## Open Issues: 7 These issues are currently being filtered

## Engineering - PUD Plan Checklist

## Branch Creek Crossing Development Plan Revision 2 - 5.4.2017.pdf

## 1. G. Grading Plan

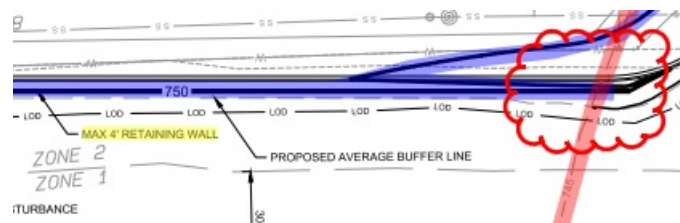
At the Site Plan stage, all stormwater from impervious surfaces is to be sent to treatment. The note shown on Sheet C3.0 indicating that stormwater is proposed to sheet flow to the bioretention area on the southern end of the site does not appear to correspond with the proposed grading on the westernmost side of the site.

## 5. General issues

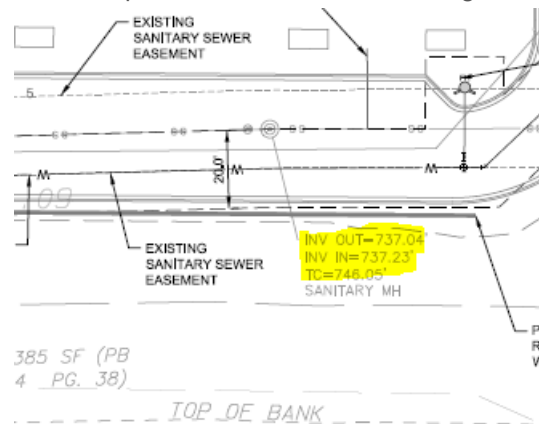
MVUD has not received application or design information for this project.

Water lines, meters, and hydrants as proposed are not approved by MVUD. General layout line sizes, and Hydrant locations have not been approved and currently does not meet design specifications of MVUD.
